DESCRIPTION:
 MODIFIED 1MM X 1MM DBL VERT SMT TERM STRIP

DWG. NO.
ASP-193073-01

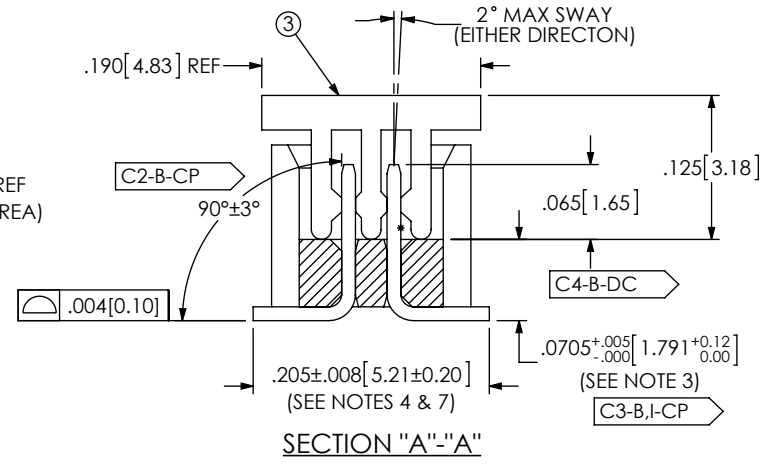
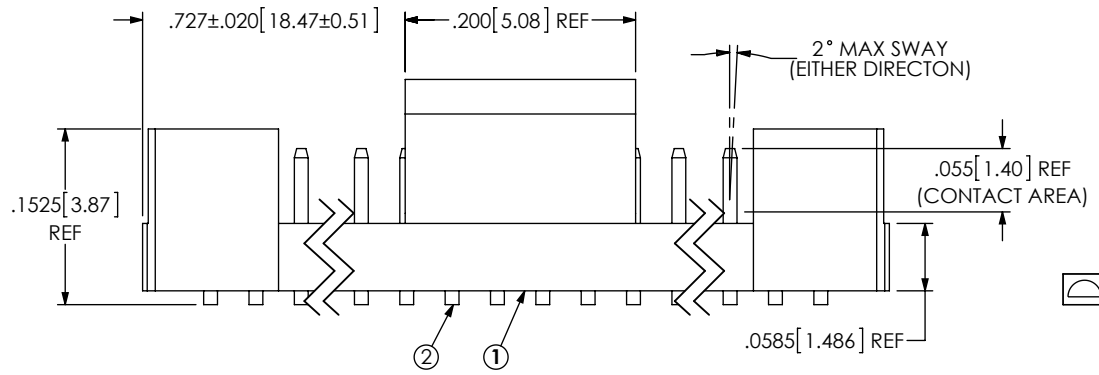
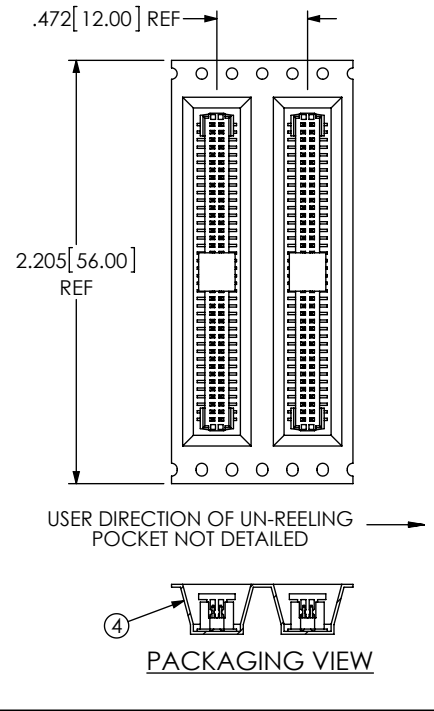
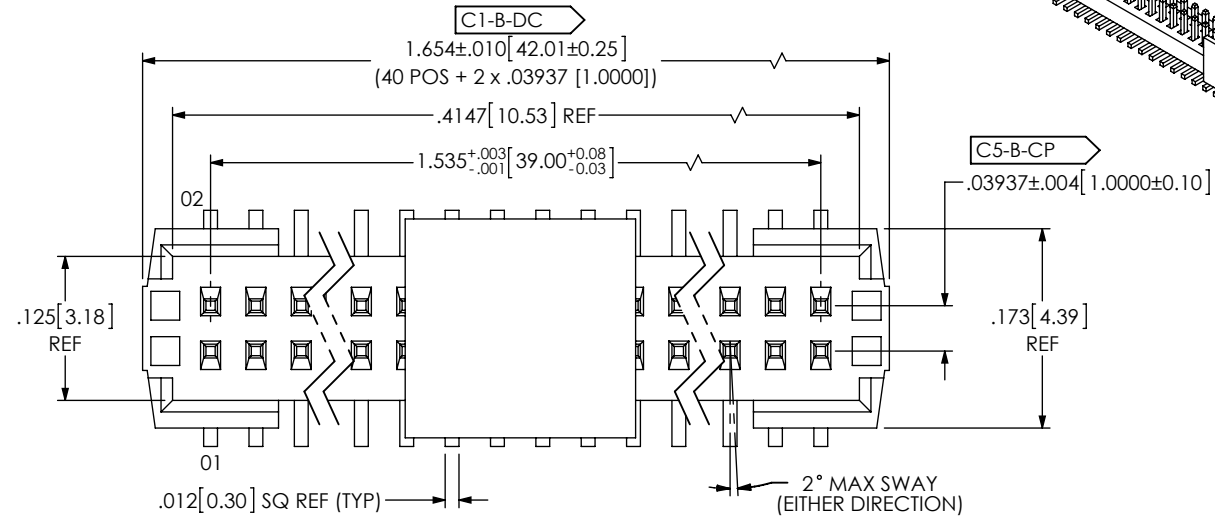
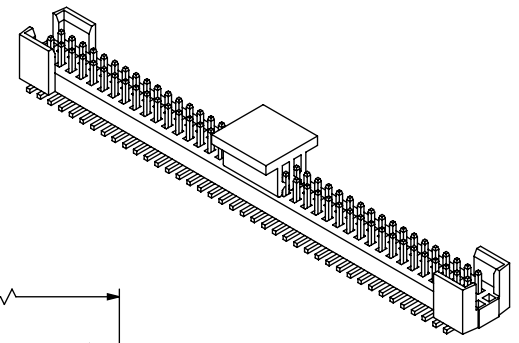
0	CW	Z Barnett
5/11/2016 ECN-274932		
ISSUE FOR REVIEW.		
1	CW	Z Barnett
5/16/2016 ECN-275267		
BOM: CHG ITEM FROM T-1S16-03-L-2 TO T-1S16-04-L; FRONT VIEW: ADD .055 REF (CONTACT AREA), SECT "A"; "A": CHG .075 TO .065.		
A	JB	Z Barnett
5/27/2016 ECN-276199		
RELEASE FOR PRODUCTION; BOM: CHG ITEM 4 CT-FTMH036MS TO CT-FTMH151MS		
B	CW	Z Barnett
6/7/2016 ECN-276767		
NOTES: CHG NOTE 1 FROM ITEM 1 NOT AVAILABLE AS STANDARD ON 5 POS" TO "USE MOLDED END SHROUDS NOT AVAILABLE AS STANDARD".
